## **FINAL DRAINAGE REPORT**

**MAYBERRY, COLORADO SPRINGS – FILING NO. 4**

**R&R JOB #MC22249  
EPC PROJECT No. SF2317**

**AUGUST 2023**

ORIFICE PLATE  
MODIFICATIONS

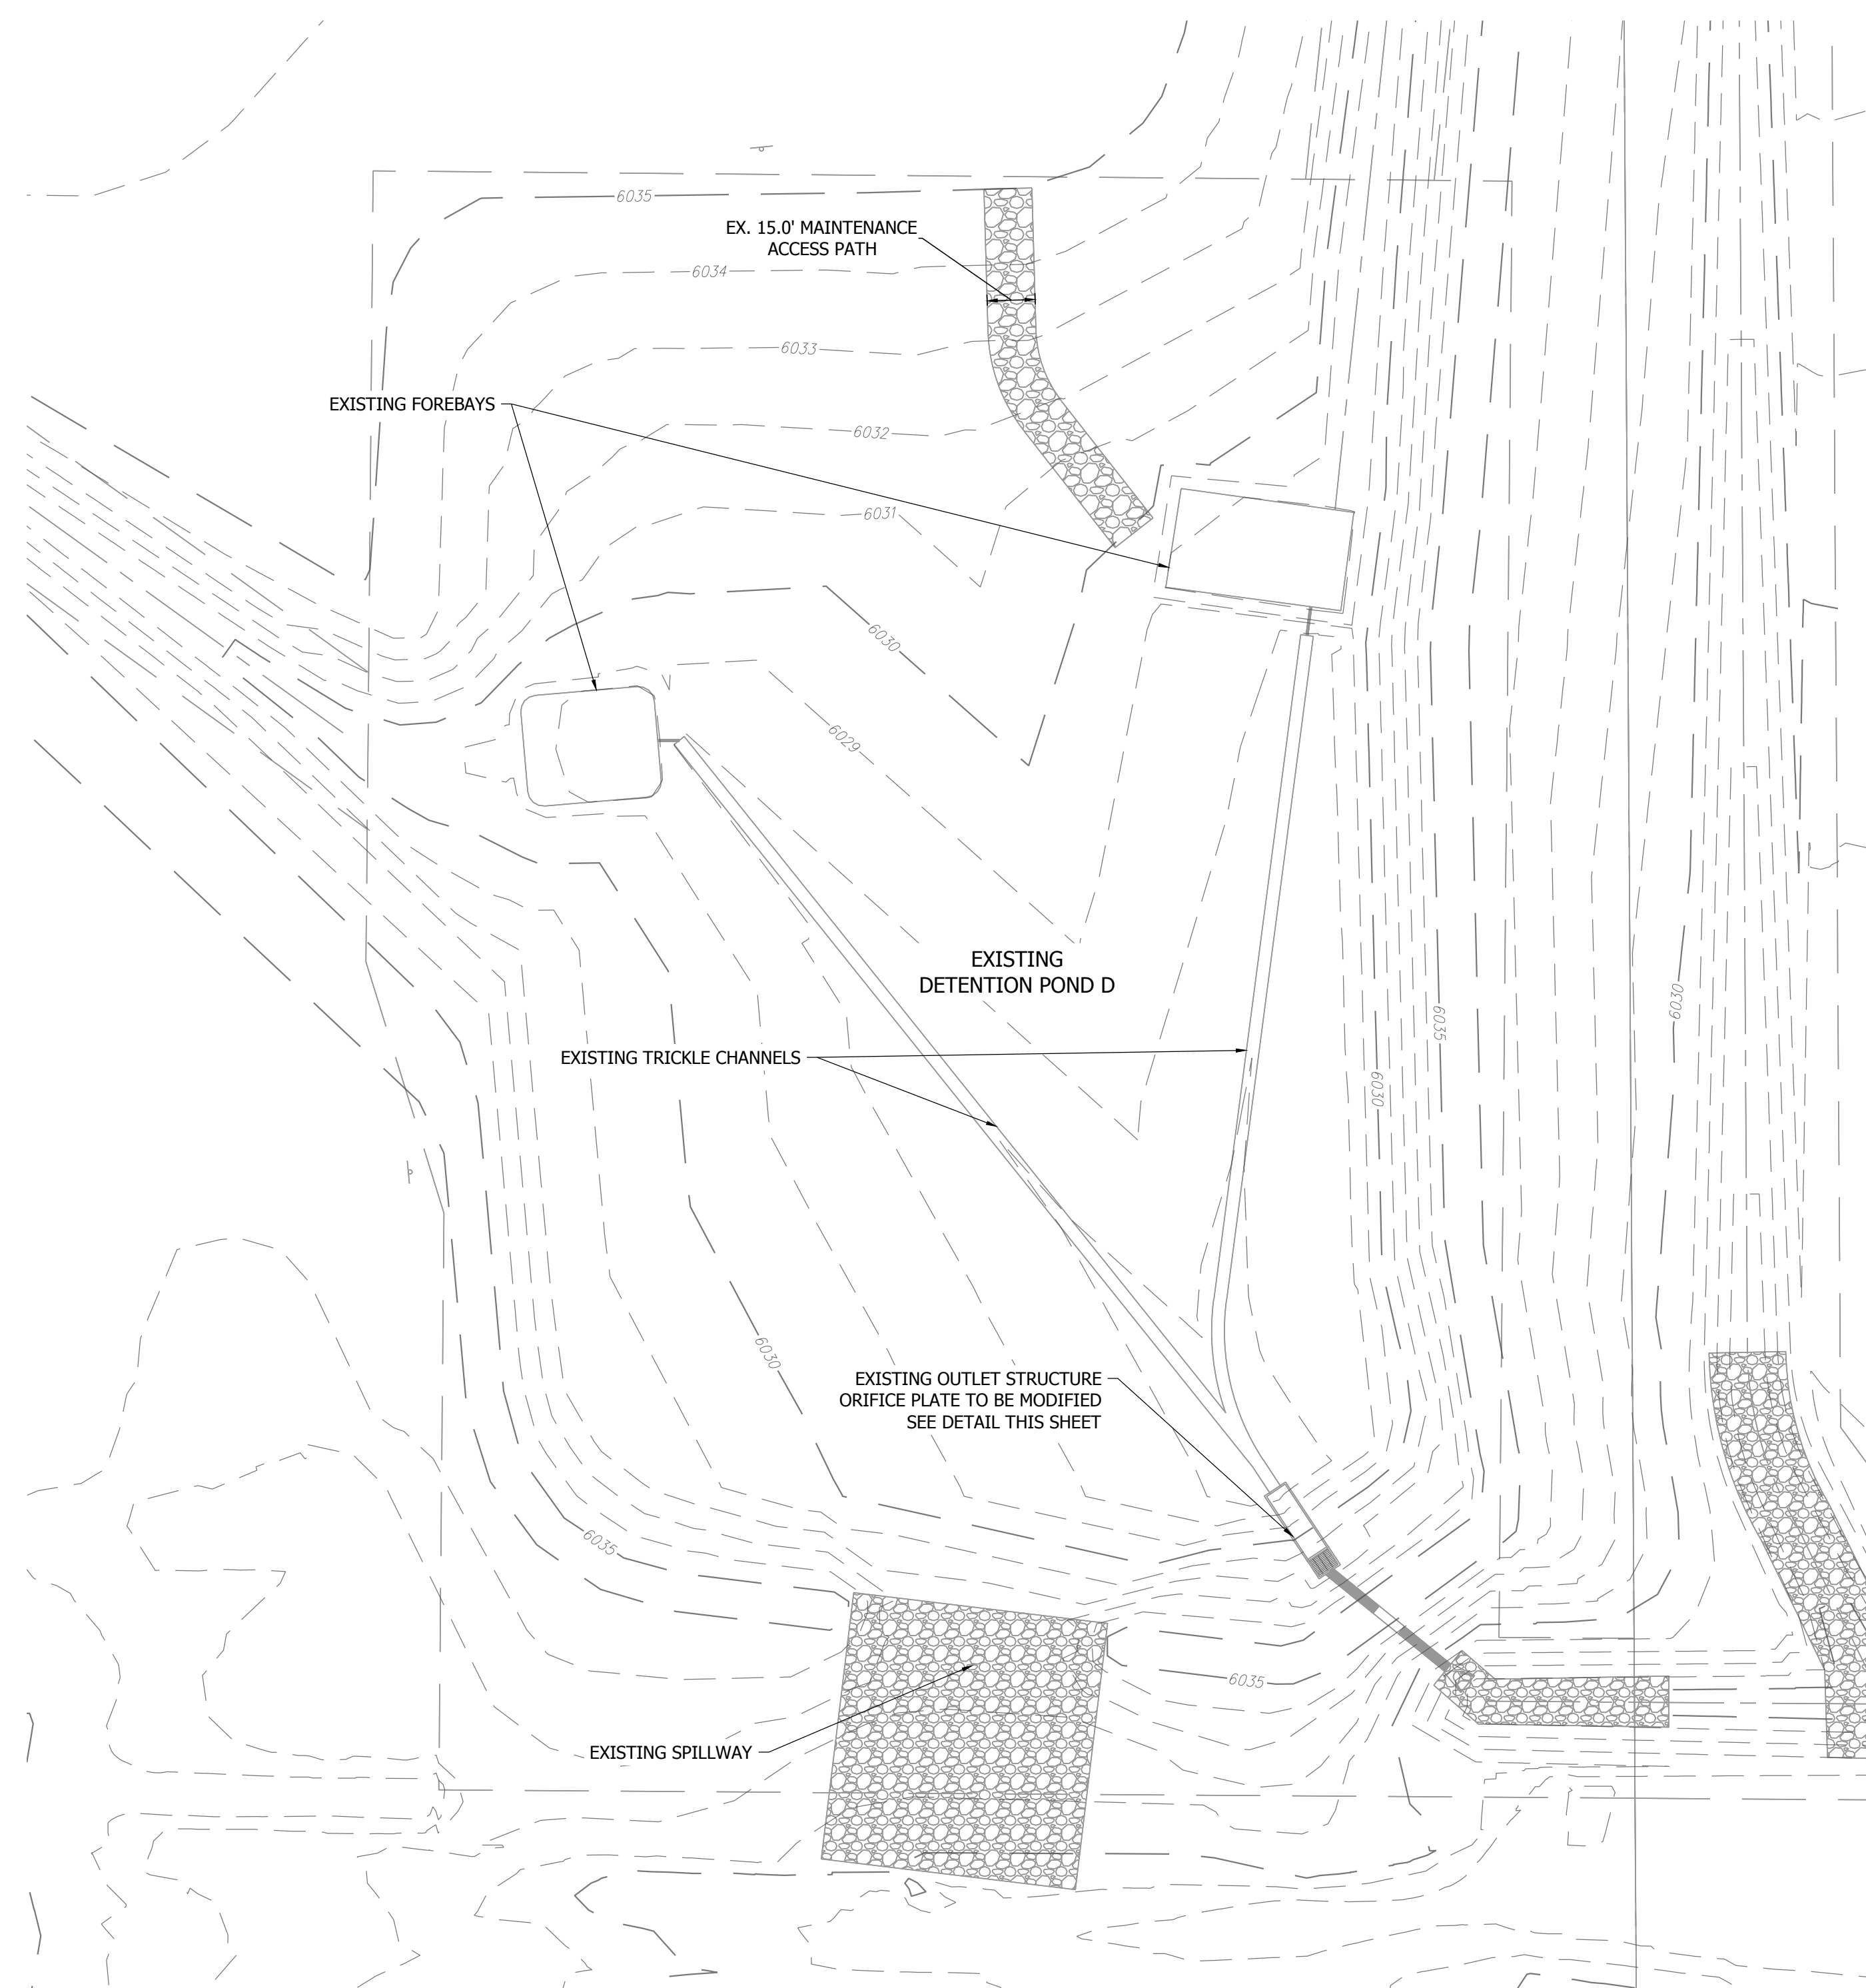
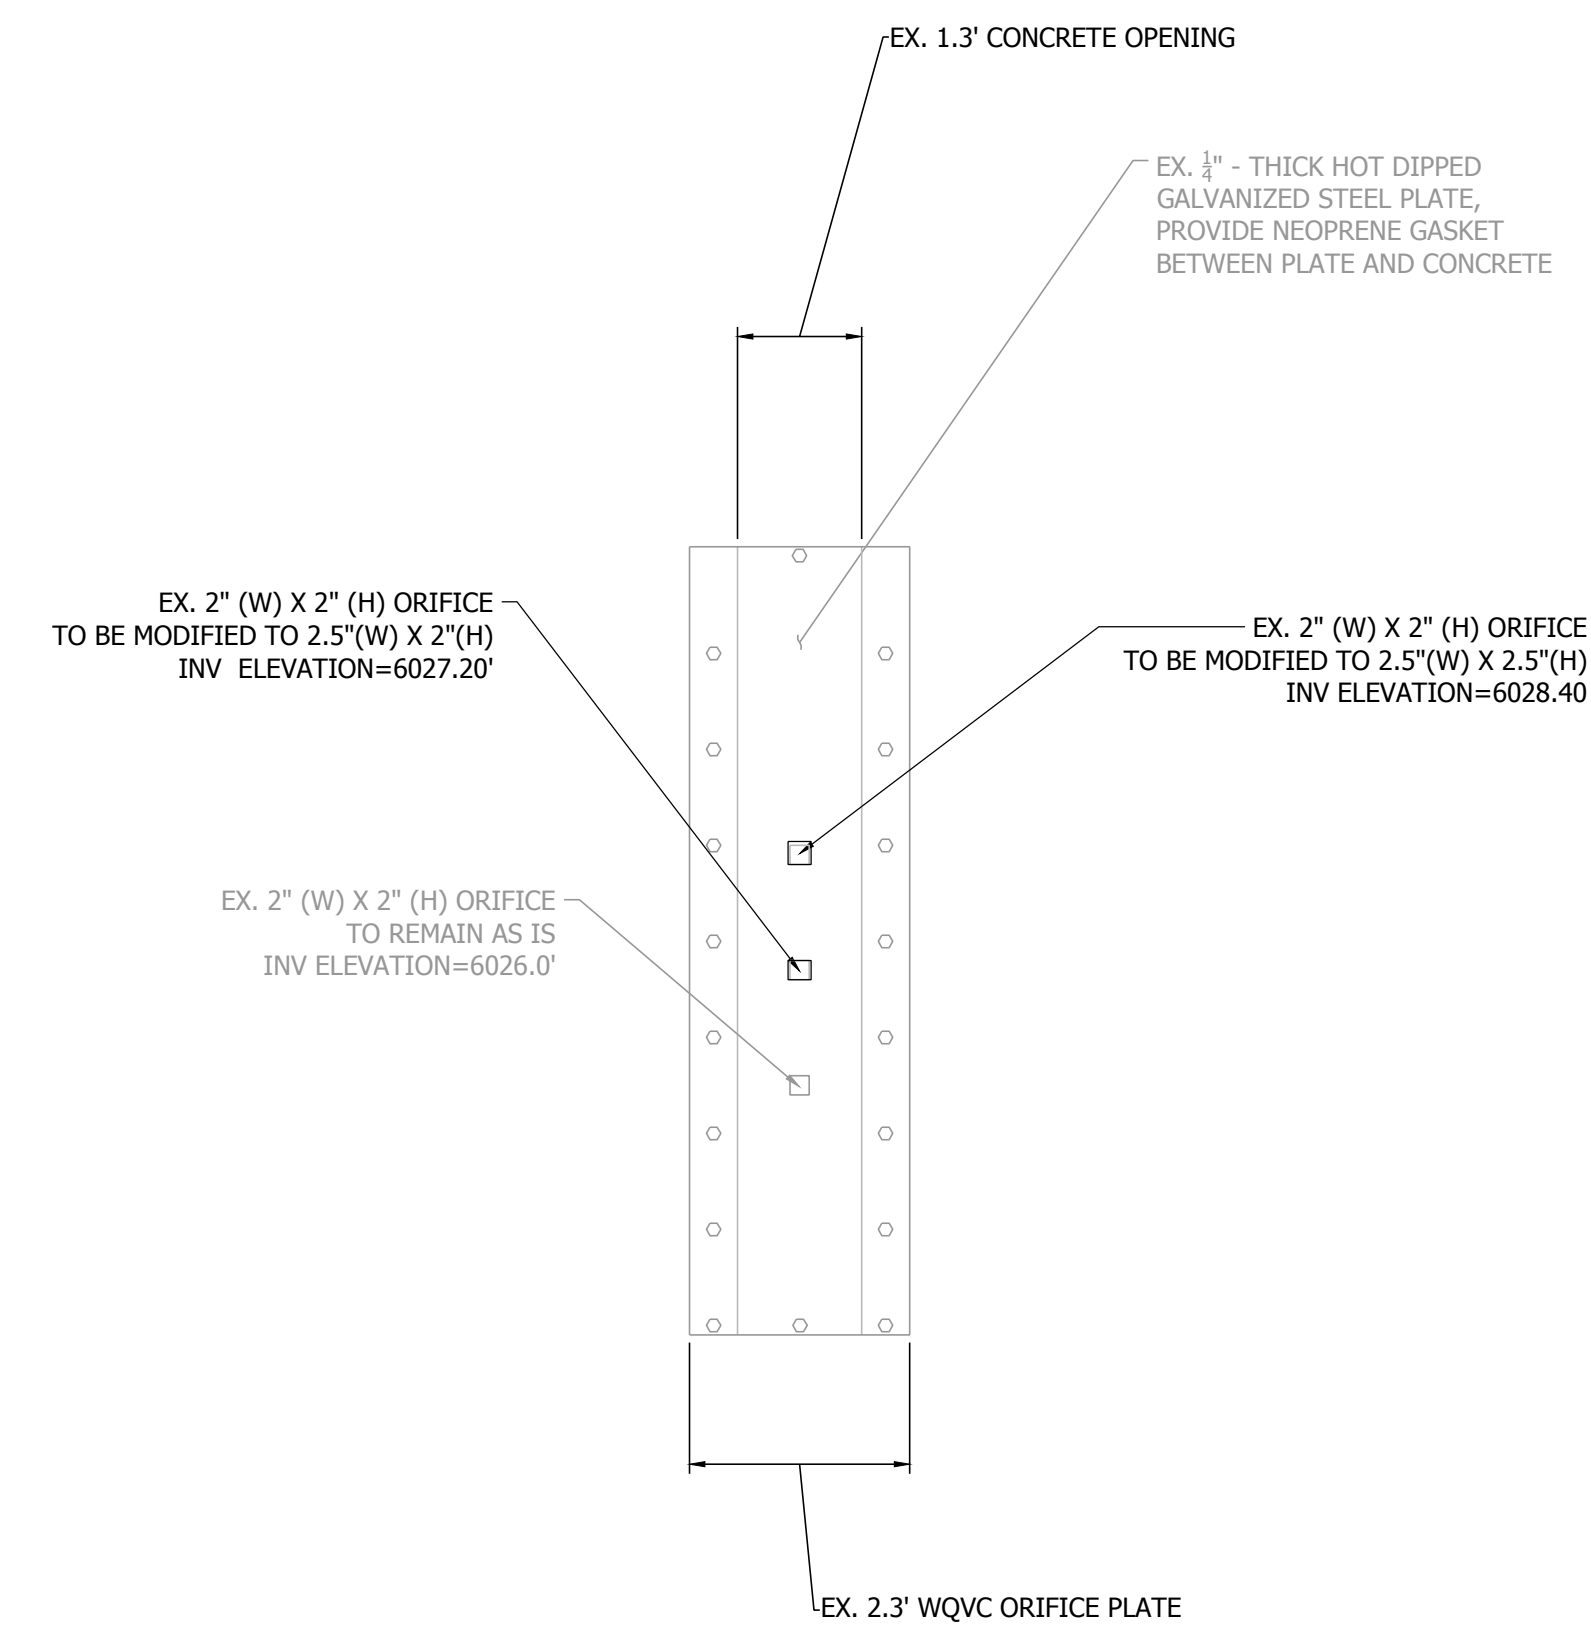
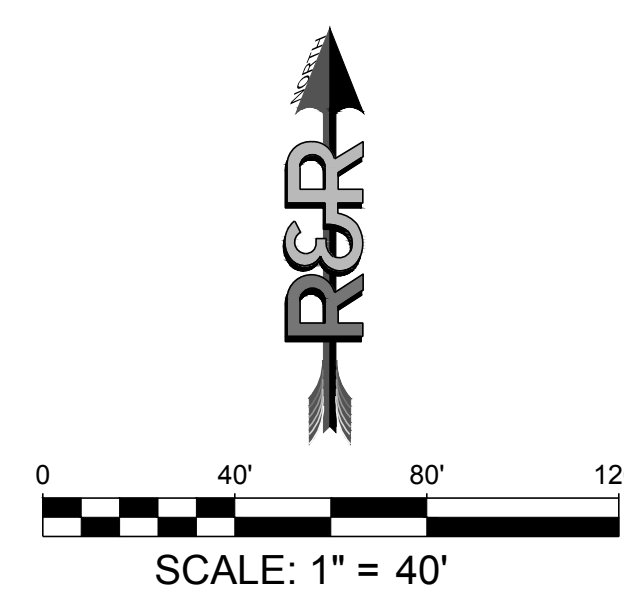
show the 100 yr WSE on the details
